CERTIFICATE OF APPROPRIATENESS

Property: 705 W. Main, Lot 11, Block 14, Lockhart Conner & Barziza

Proposal: Alteration – porch deck replacement

Figure 4 - View of porch floor after work completed

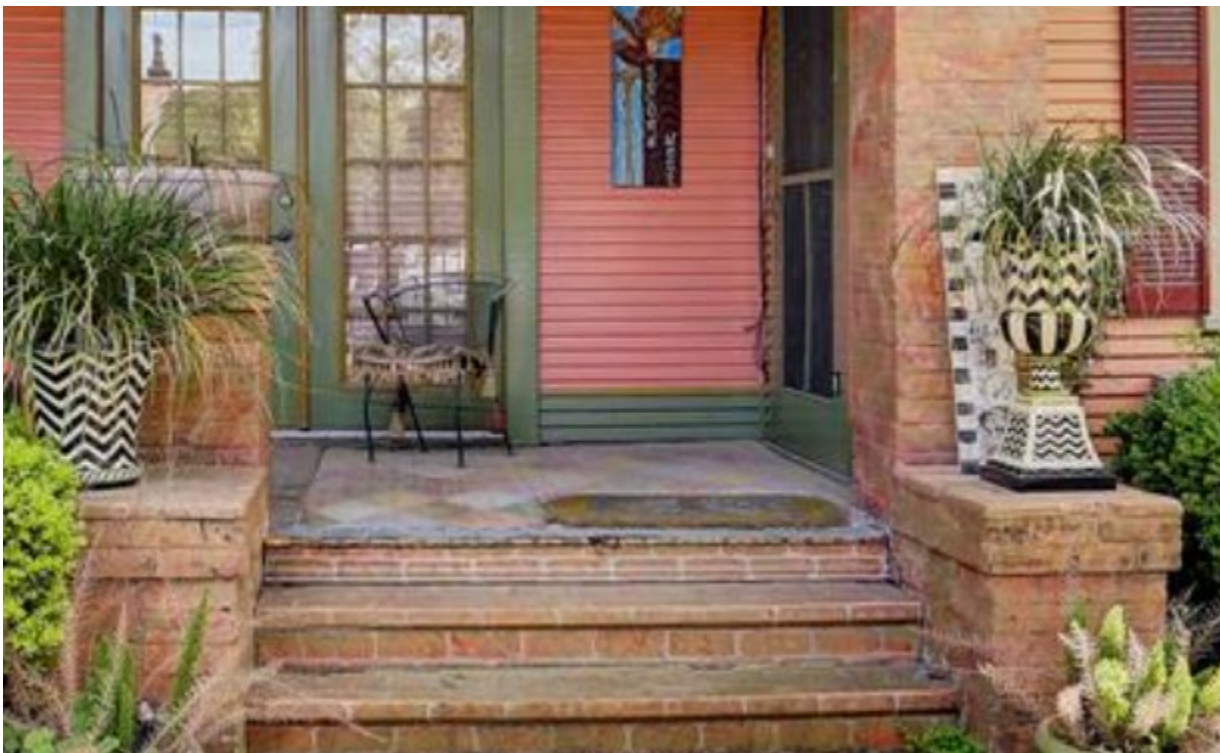
- Applicant worked without a permit and replaced the porch floor decking with 2"x 6" pine wood

<i>Replacing original porch flooring with 2x material does not retain and preserve the character of the front porch. The original material was or would have been nominal 1" x 4' tongue and groove</i> |

4. The materials he chose ARE NOT of like kind or in keeping with the original historic materials, rather he chose pressure treated 5/4 X 6 deck boards instead of 1X4” pine or cypress tongue and groove porch boards (which are currently available to purchase from multiple hardware stores, such as Lowes or lumber yards).

Recommendation: Denial - does not satisfy criteria 1, 4, 5, 9 & 10 and issuance of a COR to remove the installed deck floor and replace the porch floor with 1"x4" T&G porch flooring wood perpendicular to the street and with slight slope towards street, as the original would have been
